**NEW YORK STATE THRUWAY AUTHORITY
DEPARTMENT OF ENGINEERING**

**ALBANY, NY
FEBRUARY 8, 2024**

**AMENDMENT NO. 1
TO**

**CONTRACT TANY 24-8
D214964
2" MILL AND INLAY, SAFETY
IMPROVEMENTS AND MISCELLANEOUS WORK
BETWEEN MILEPOST 47.6+/- AND MILEPOST 60.1+/-
IN THE NEW YORK DIVISION
OF THE NEW YORK STATE THRUWAY
IN ORANGE COUNTY**

TITLE OF PROJECT PAVEMENT RESURFACING AND SAFETY IMPROVEMENT	CONTRACT NUMBER: TANY 24-8
LOCATION OF PROJECT NY DIVISION MP 48.0 TO 60.1	DATE: 1/2024
TITLE OF DRAWING GENERAL PLAN	DRAWING NUMBER: GP-23

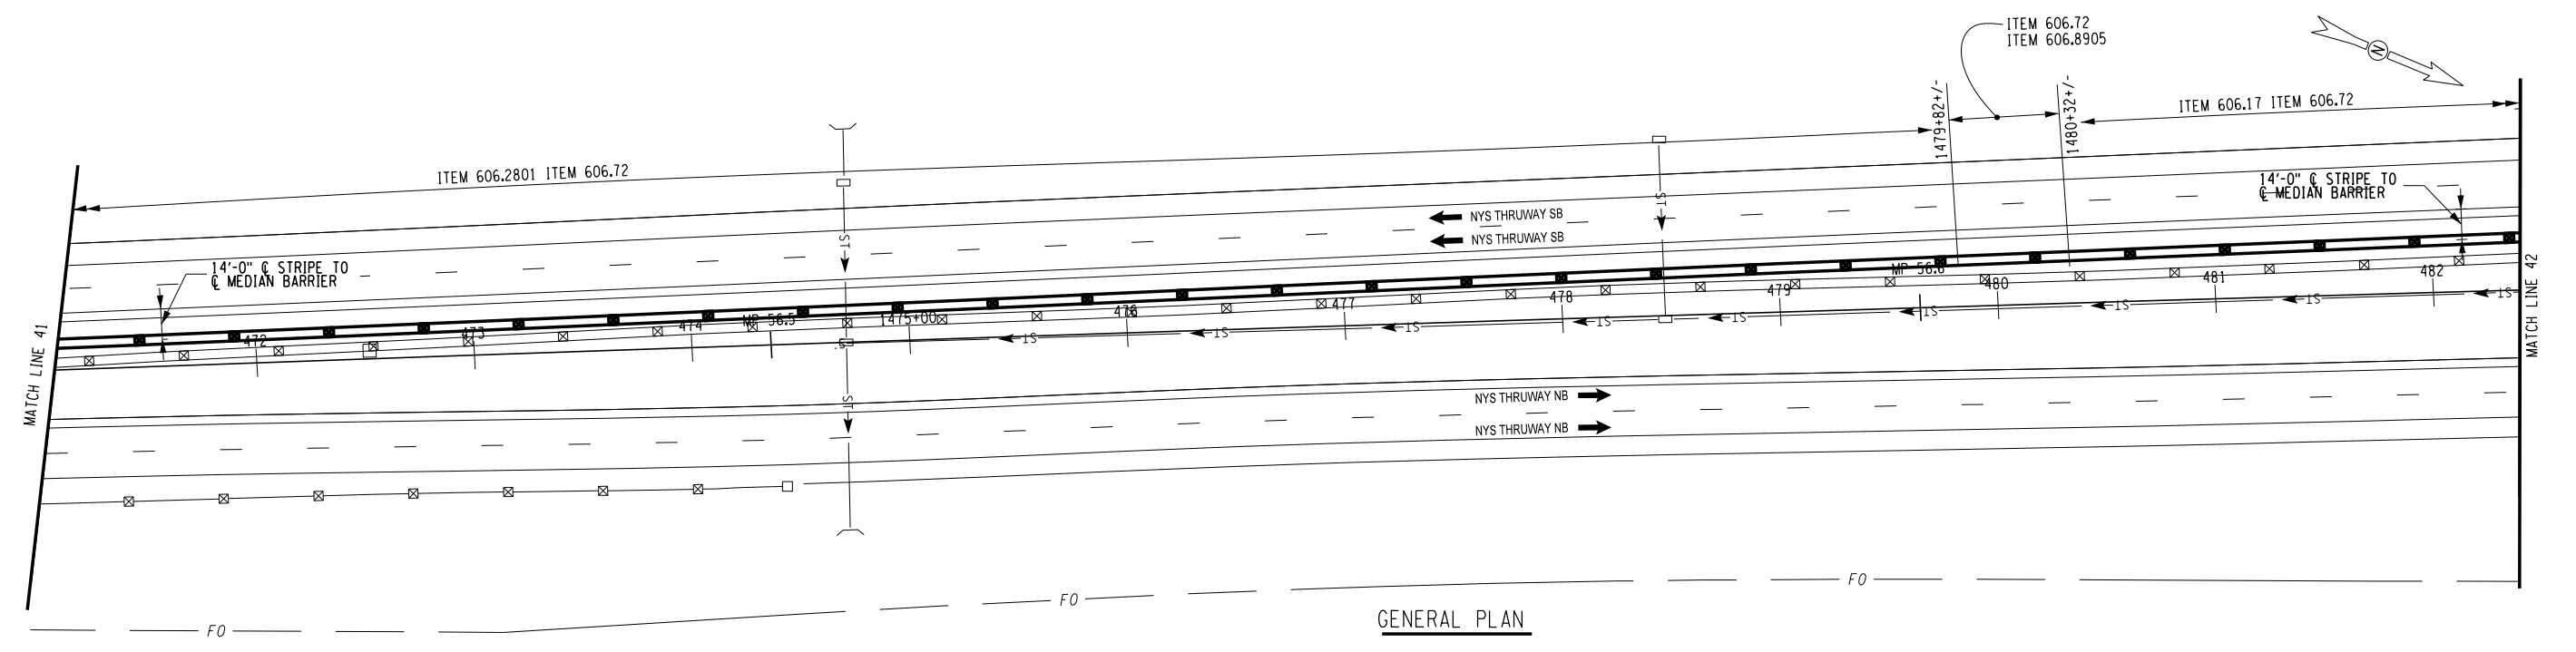
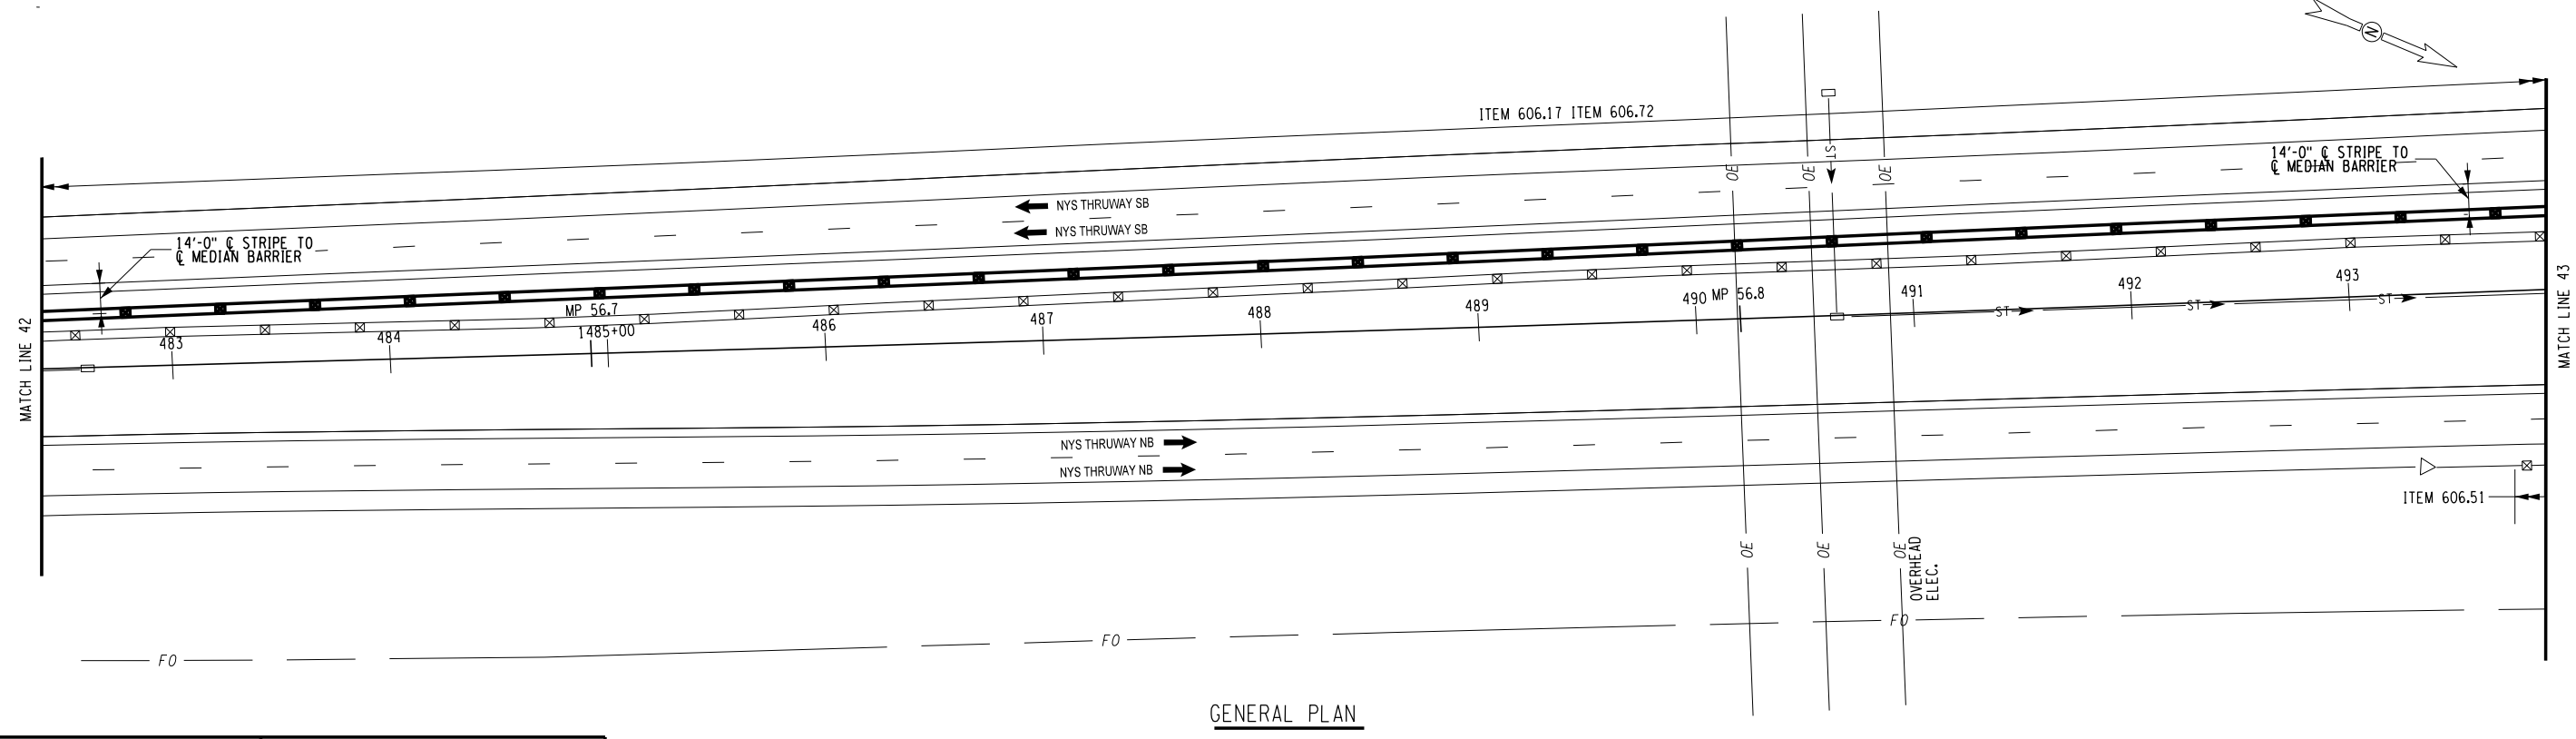
28. **DELETE** Drawing Number GP-23, Sheet 94 of 108, and **SUBSTITUTE** with the attached Drawing Number GP-23, Sheet 94-A1 of 108. Added a dimension line with locations of proposed items 606.2801, 606.17, & 606.72 extents.

TITLE OF PROJECT PAVEMENT RESURFACING AND SAFETY IMPROVEMENT	CONTRACT NUMBER: TANY 24-8
LOCATION OF PROJECT NY DIVISION MP 48.0 TO 60.1	DATE: 1/2024
TITLE OF DRAWING GENERAL PLAN	DRAWING NUMBER: GP-25

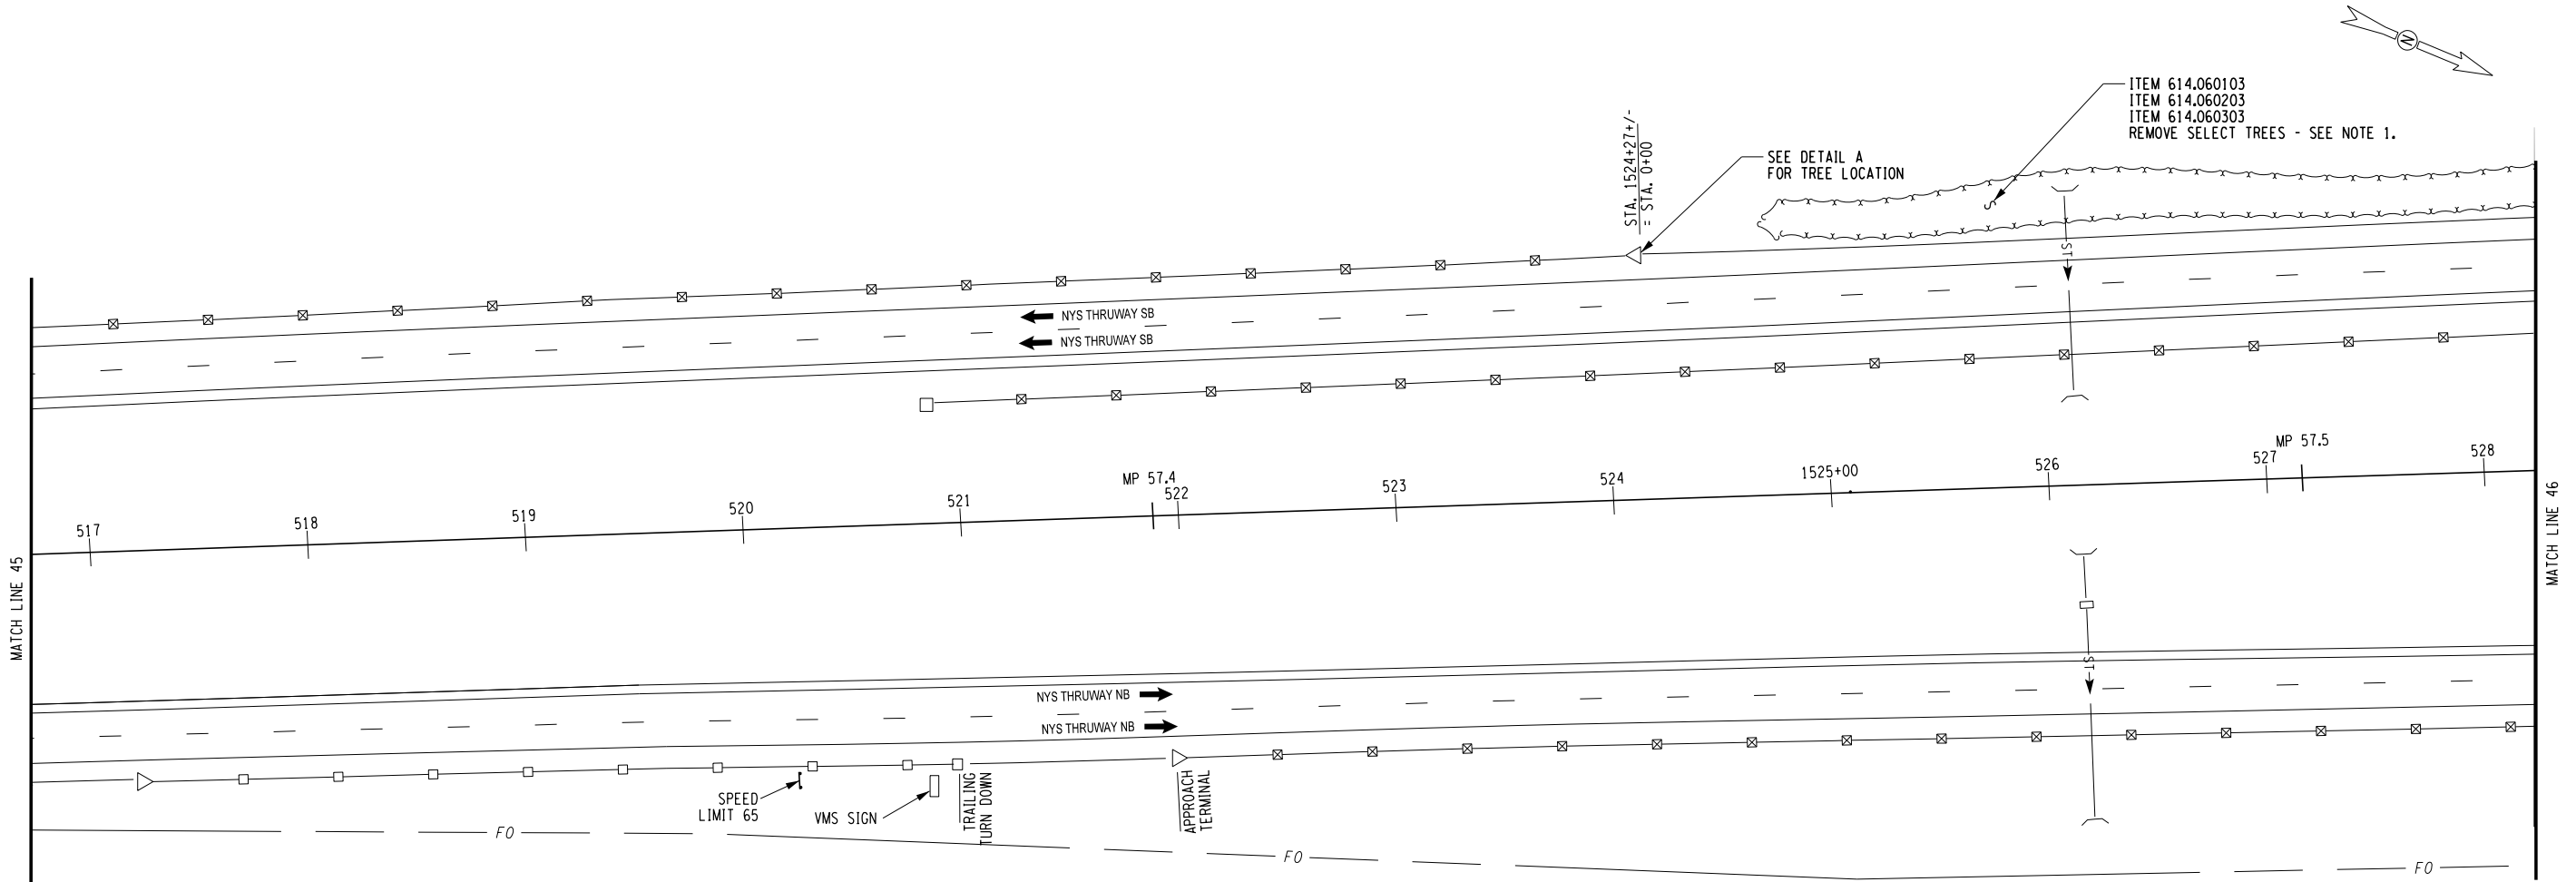
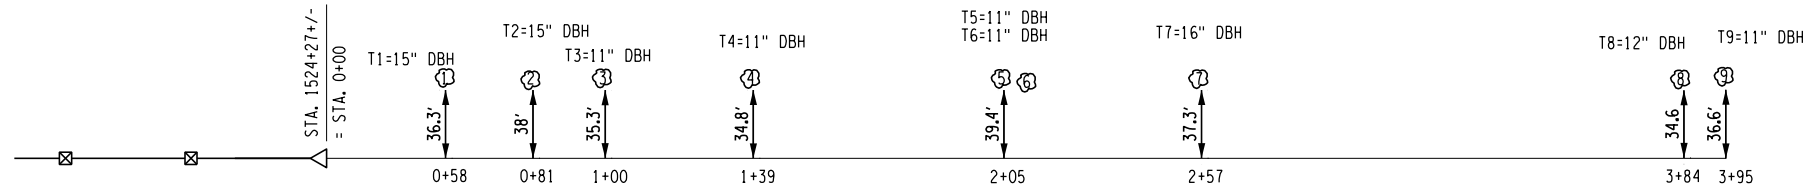
30. **DELETE** Drawing Number GP-25, Sheet 96 of 108, and **SUBSTITUTE** with the attached Drawing Number GP-25, Sheet 96-A1 of 108. Added stations for tree removals. Changed tree from 8” to 12” DBH.

- NOTES:
1. REMOVE 15" +/- DIA. WALNUT TREE PLUS 8 OTHER TREES (FIVE ARE 6" TO 12" DIA AND FOUR ARE 12" TO 18" DIA.) A.O.B.E. GRIND STUMPS TO 4" BELOW GRADE AND COVERED TO MATCH EXISTING GRADE, WITH TOP SOIL, SEED AND ESTABLISH TURF. REFER TO DRAWING TR-1.

Thruway Authority	TITLE OF PROJECT PAVEMENT RESURFACING AND SAFETY IMPROVEMENT	CONTRACT NUMBER: TANY 24-8
	LOCATION OF PROJECT NY DIVISION MP 48.0 TO 60.1	DATE: 1/2024
	TITLE OF DRAWING GENERAL PLAN	DRAWING NUMBER: GP-28

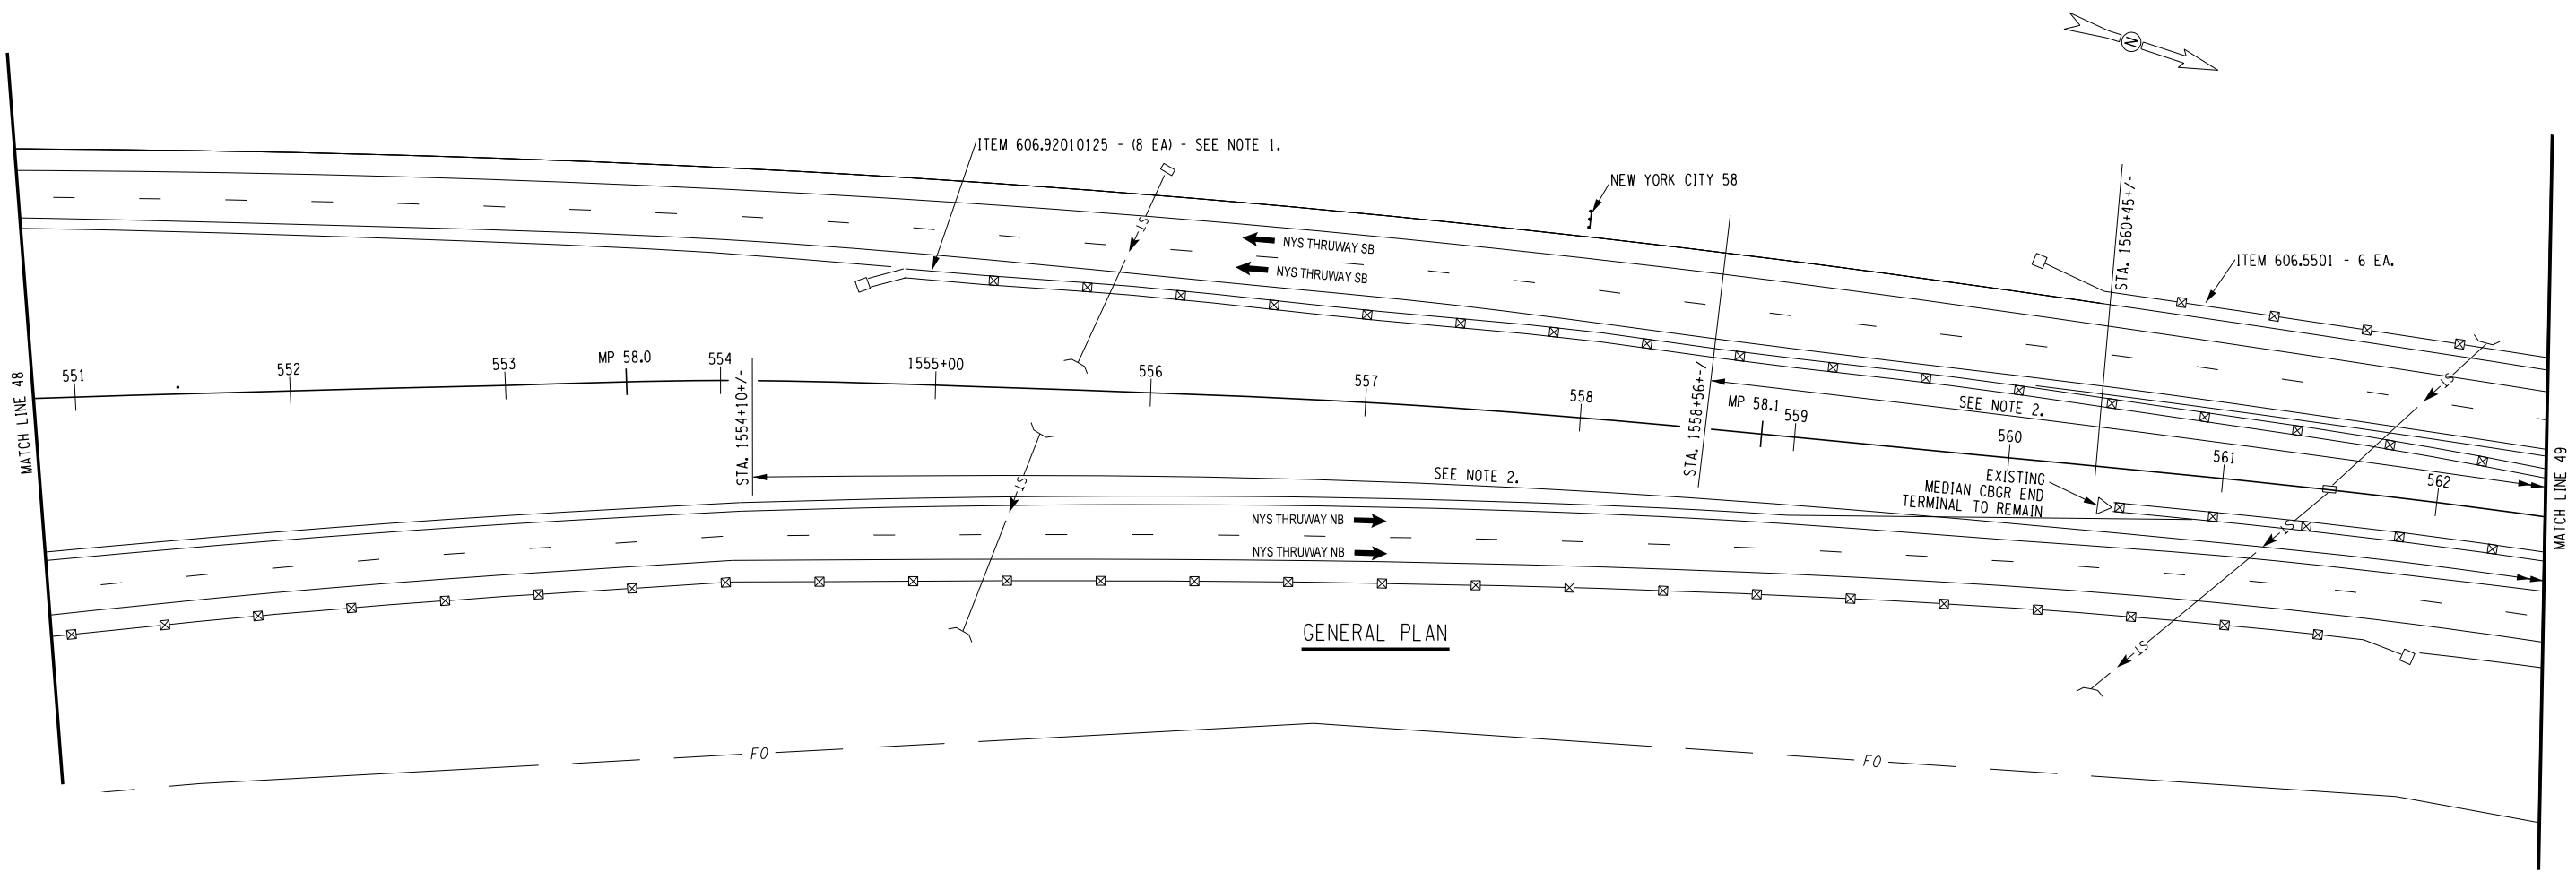
31. **DELETE** Drawing Number GP-28, Sheet 99 of 108, and **SUBSTITUTE** with the attached Drawing Number GP-28, Sheet 99-A1 of 108. Changed Note 2. to read “LEFT SHOULDER...”.

- NOTES:
1. REPLACE GUIDE RAIL SPLICE BOLTS ITEM 606.92010125.
 2. LEFT SHOULDER WITHIN THE LIMITS SHOWN ARE NOT TO BE PAVED.
